HYUNDAI NEW THINKING. NEW POSSIBILITIES. Technical Service Bulletin	GROUP	NUMBER
	AUTOMATIC TRANSMISSION	13-AT-012-1
	DATE	MODEL
	SEPTEMBER 2013	Tucson (LM), Santa Fe (CM/AN/NC), Sonata (YF), Elantra (UD/MD/GD/JK), Accent (RB), Azera (TG/HG), Veloster Turbo (FS)
SUBJECT:	AUTOMATIC TRANSAXLE (6-SPEED) OIL TEMPERATURE SENSOR DTC P0711, P0712 & P0713

This TSB supersedes bulletin 13-AT-012 to add Op Codes.

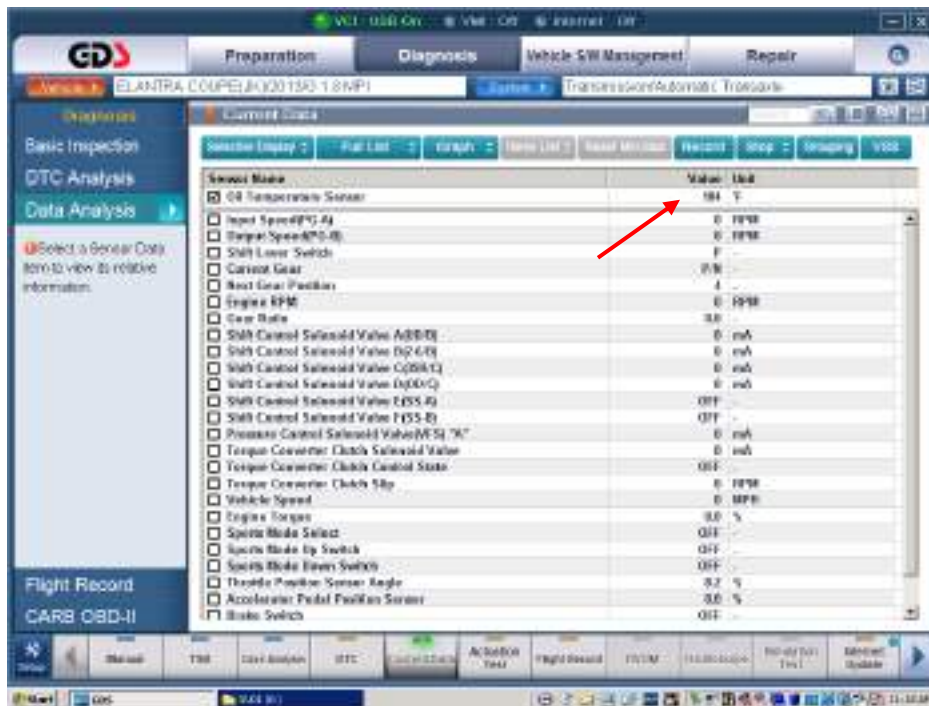
The oil temperature sensor has been integrated with the internal harness from early March, 2013. The oil temperature sensor is not available separately for these models.

Previous (separate parts)	New (integrated parts)
Oil temperature sensor and internal harness
